California Ridge Wind Farm Champaign County, IL

Natural Resource Report

October 6, 2011

California Ridge Wind Farm Natural Resource Report Summary

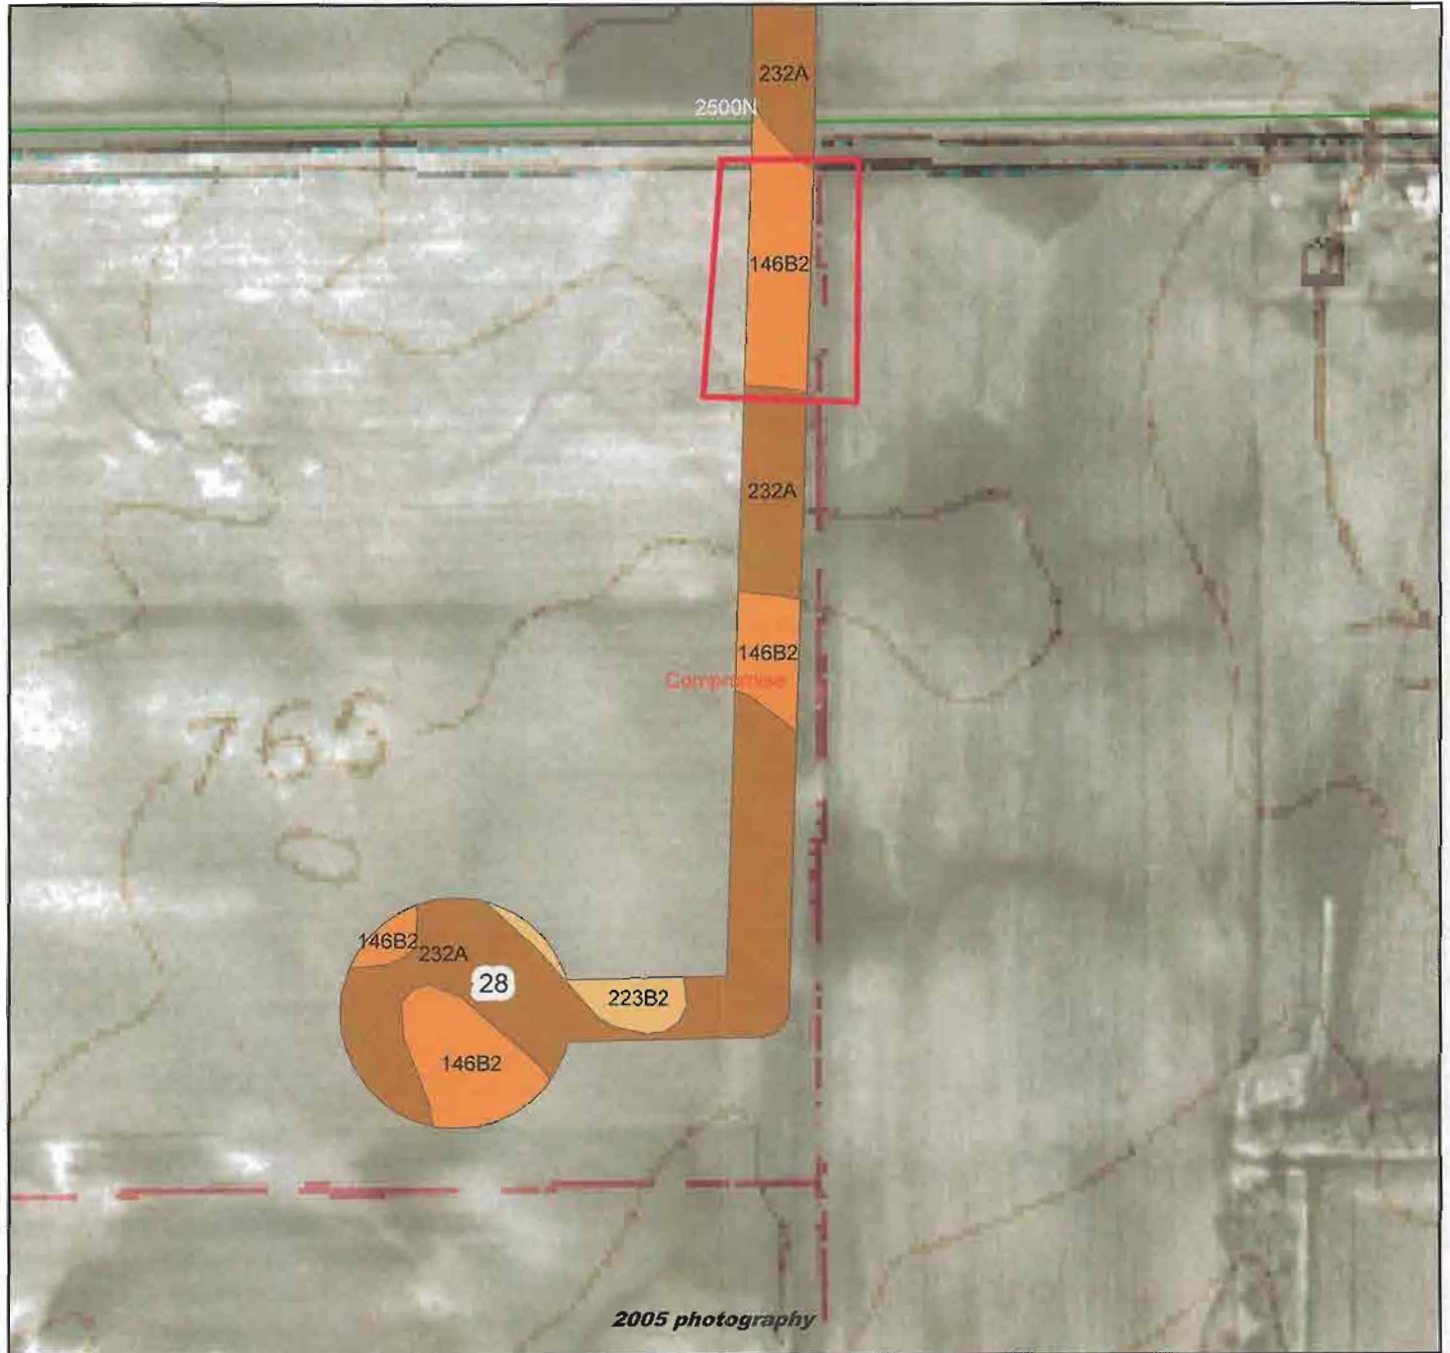
The 146B2 (Elliott Silty Clay Loam) soil has a 2-4% slope that could be an issue with water flowing over the access road possibly causing erosion of the road surface or depositing silt on the access road.

The 223B2 (Varna Silt Loam) soil has 2-4% slopes that could be an issue with water flowing over the access road possibly causing erosion of the road surface or depositing silt on the access road.

The area most susceptible is outlined in a red rectangle. There are several small areas of these soil types, but they don't look large enough to be significant.

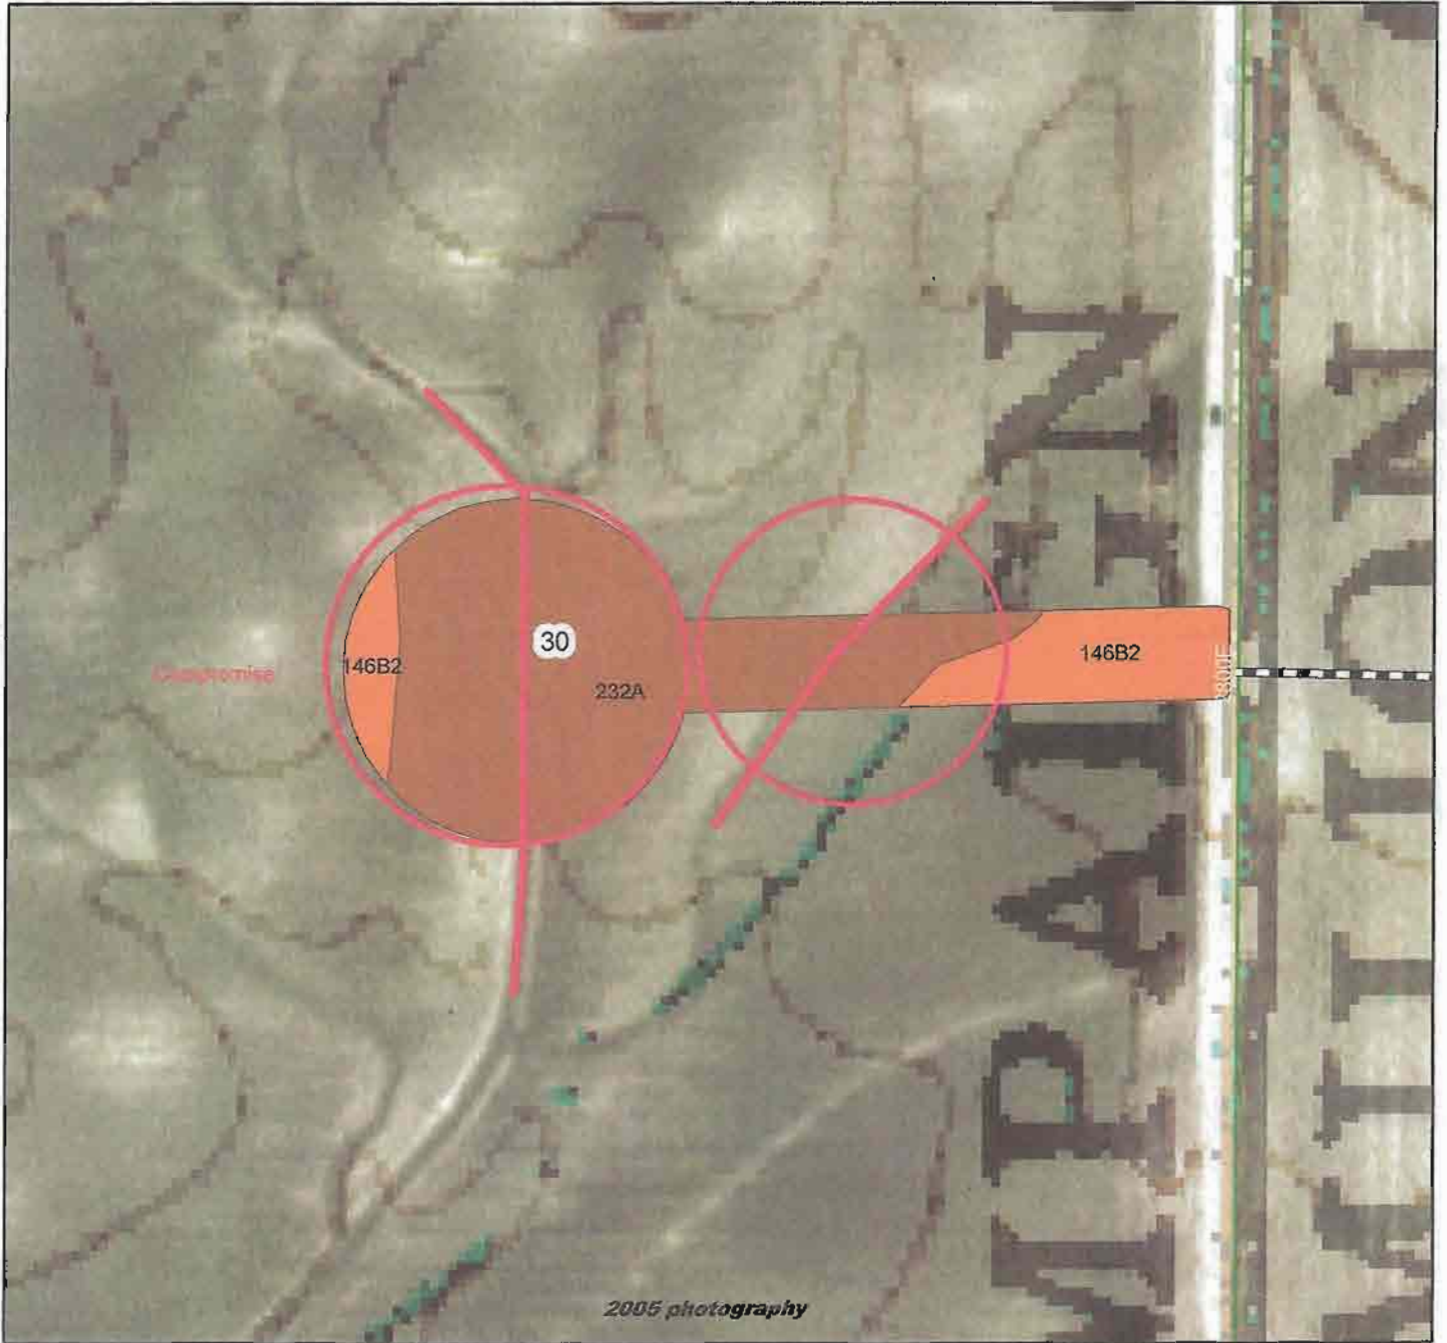
The 146B2 (Elliott Silty Clay Loam) soil has a 2-4% slope that could be an issue with water flowing over the access road possibly causing erosion of the road surface or depositing silt on the access road. The area is small and probably won't cause a problem.
